UNITED STATES
ATOMIC ENERGY COMMISSION
WASHINGTON, D.C. 20545

Change No. 14
License No. DPR-6

CHANGES TO TECHNICAL SPECIFICATIONS

CHANGE NO. 14

FIGURE 5.7 BIG ROCK POINT E FUEL

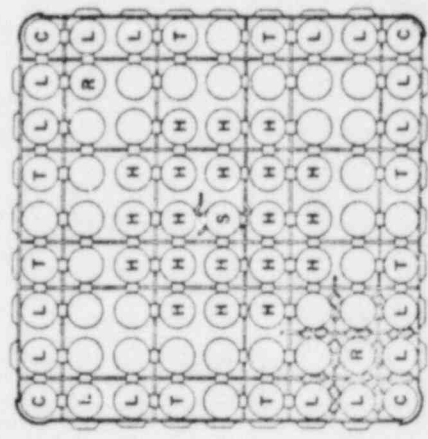
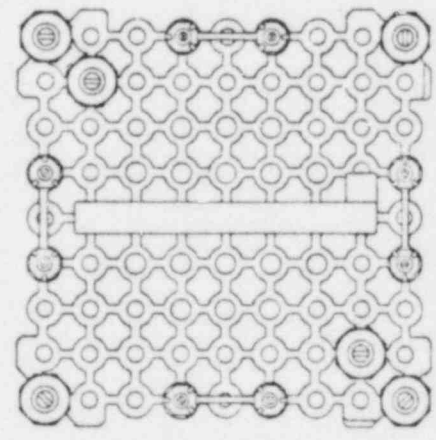
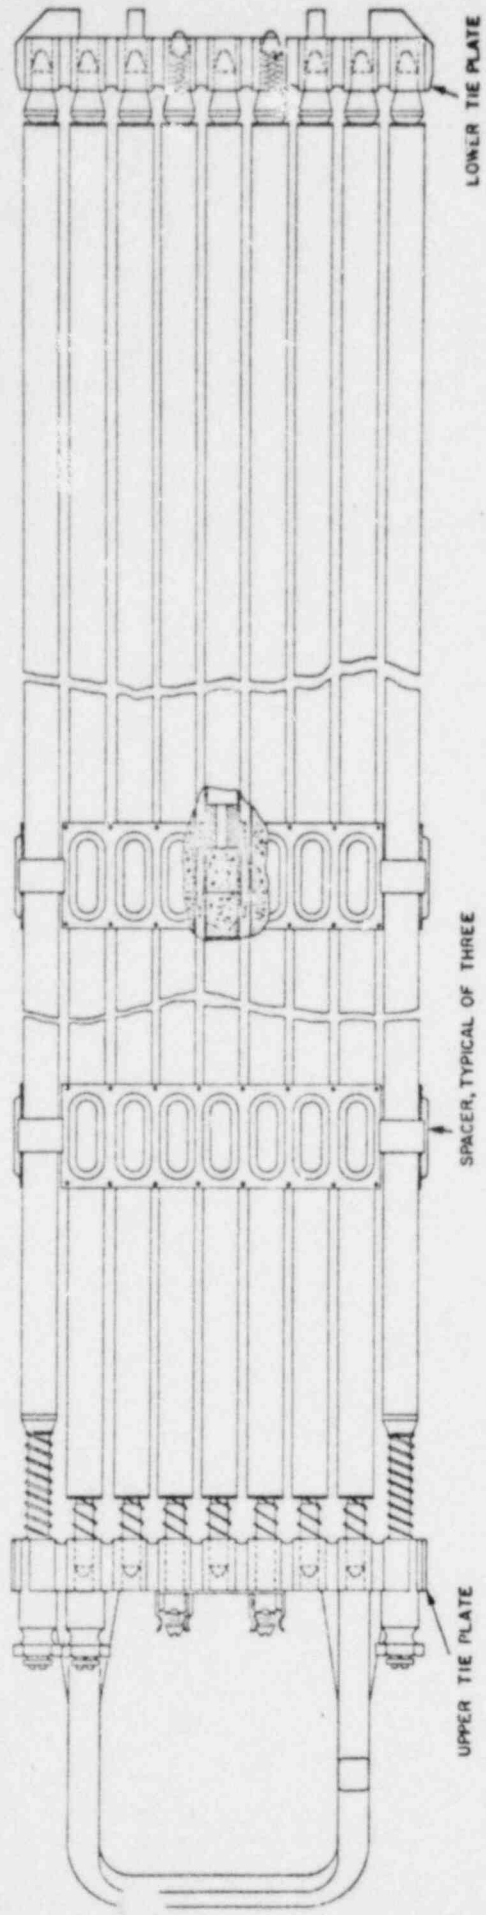
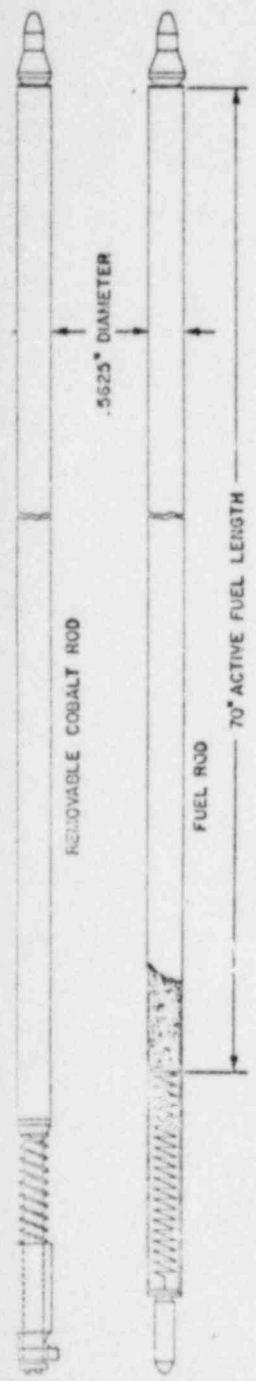
2. Delete the present table of fuel parameters following section 5.1.5(c) and replace it with the attached.
3. Add the attached Figure 5.7 to the fuel assembly figures following Section 5.
4. Delete the present Section 5.2.1(b) and replace it with the following:

The general dimensions and configuration of the six types of fuel bundles shall be as shown in Figures 5.2, 5.3, 5.4, 5.5, 5.6, 5.7 and 8.1 of these specifications. Principal design features shall be essentially as follows:"

- * Four Special Fuel Rods at Bundle Corners Are Segmented
- ** Reload B, C & E Fuel Bundles May Contain (in the Corner Regions of the Bundle) Four Zircaloy-2 Tubes Having Encapsulated Cobalt Targets Sealed Within
- *** Reload E Fuel Bundles Have a Special Central Fuel Rod To Which the Bundle Spacers are Fixed. In Addition, Two of the Interior Bundle Fuel Rods Are Removable
- # Special Rods Have Depleted Uranium

- S - SPACER CAPTURE ROD (HIGH ENRICHMENT)
- H - HIGH ENRICHMENT RODS
- T - TIE RODS (MIDDLE ENRICHMENT)
- L - LOW ENRICHMENT POWER CORRECTION RODS
- C - REMOVABLE COBALT RODS
- R - REMOVABLE FUEL RODS (MIDDLE ENRICHMENT)
